## NAA Safety Alert

**Date:** May 5, 2016

**Subject:** Removal of Foam Belt Protector

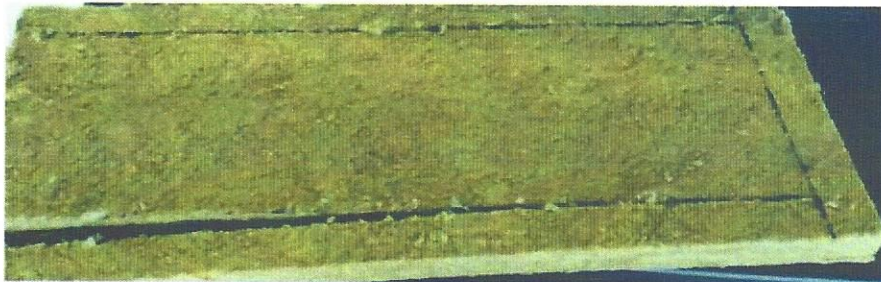
G20 Counterweight Frames and Car Top Sheaves are provided with a foam belt protector that is used during construction to keep debris from entering the area between the belt and the sheave.

It has been discovered that the foam protector may be flammable and must be removed.

In order to protect the belts and sheave from debris, order and install durable mineral wool that has been approved for this purpose (Florence part # AAA27CJ2).

The mineral wool product can also be ordered from McMaster-Carr under part # 9328K41.
